STATE OF NEW YORK : COUNTY OF ORANGE
TOWN OF NEWBURGH PLANNING BOARD

FRISCHKNECT
(2015-06)

INITIAL APPEARANCE
LOT SUBDIVISION

**TOWN OF NEWBURGH
PLANNING BOARD
TECHNICAL REVIEW COMMENTS**

**EXISTING SURVEY/
PROPOSED SUBDIVISION**
SCALE 1" = 20'

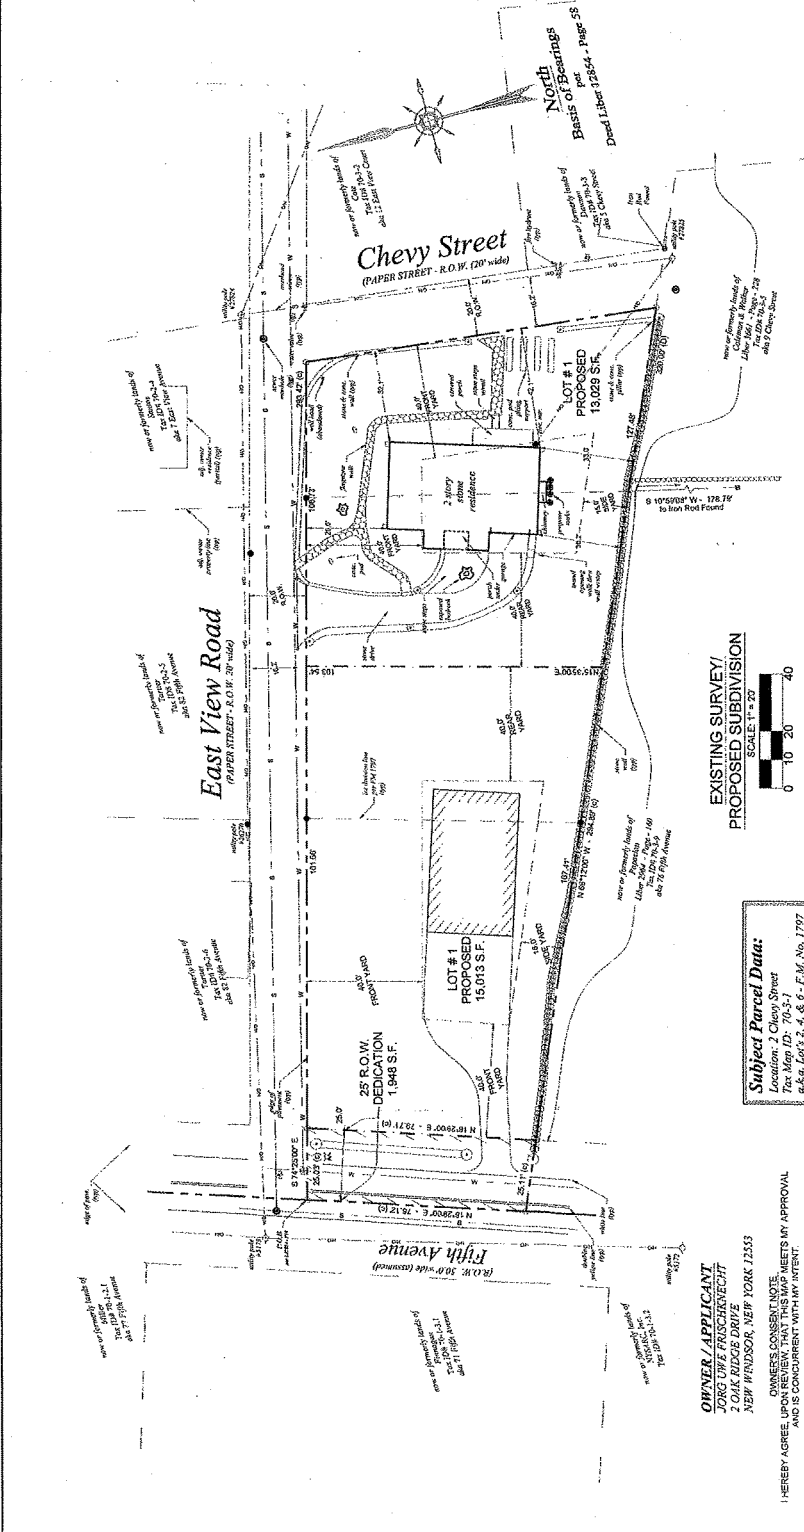
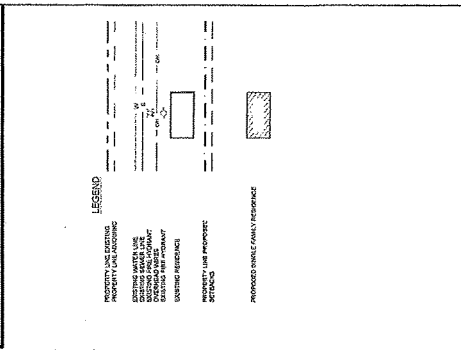
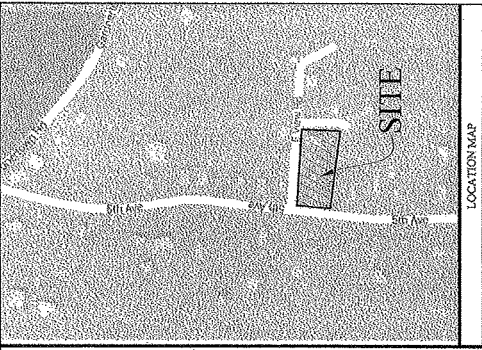
6 MR. HINES: Our first comment
7 identifies the two front yard setbacks. It's a
8 corner lot on the two private roads there. That
9 will need a variance.
10

22 It appears, based on the grading plan,
23 that there's a potential for rock on the site, so
24 we're requesting that you address in the EAF if
25 there's going to be blasting and take a look at

how that's going to work on the site. If looks like there's a rock knob, based on the grading, right where the house is going to be.

MR. HINES: The way that lot sits, it's going to have to be two stories in the front, one story in the back because of the grading.

1. Project will require referral to the Zoning Board of Appeals for 2 front yard variances for the existing structure on the site.
2. Project identifies a roadway dedication parcel. Information for this must be submitted for attorney review.

6. Project should address whether blasting is to occur on the site. The design of the house appears to set the easterly most portion of the building of approximately 10 feet into the hillside.
